BEFORE THE STATE OF WASHINGTON
ENERGY FACILITY SITING EVALUATION COUNCIL

Scout Clean Energy, LLC, for
Horse Heaven Wind Farm, LLC,
Applicant.

DOCKET NO. EF-210011

PRE-FILED TESTIMONY OF TCC
WITNESS PAUL KRUPIN

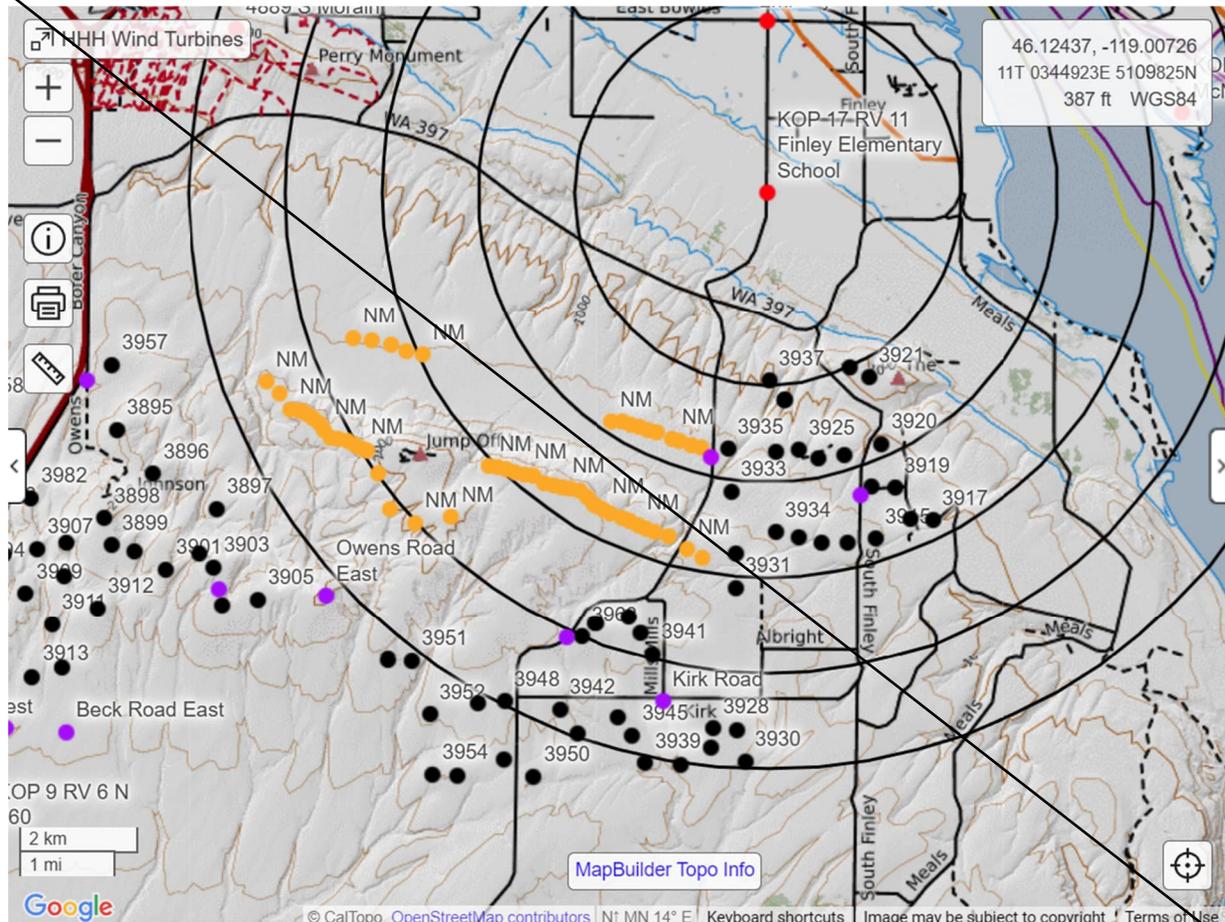
1 This graphic contains 4-mile, 5-mile, and six-mile range rings around the residential
2 the Symphony Ridge Development on Thompson Hill residential community from
3 South 26th St.

4
5 In this case, the turbines within the two-mile, three-mile, four-mile, five mile and six-
6 mile radius should be removed from consideration in the project and deemed to close
7 and intrusive to people due to the visual impact. The proposed HHWF turbines are
8 larger, closer and more intrusive than the Nine Mile turbines. Finley should not be
9 forced to experience increased visual impacts from the project.
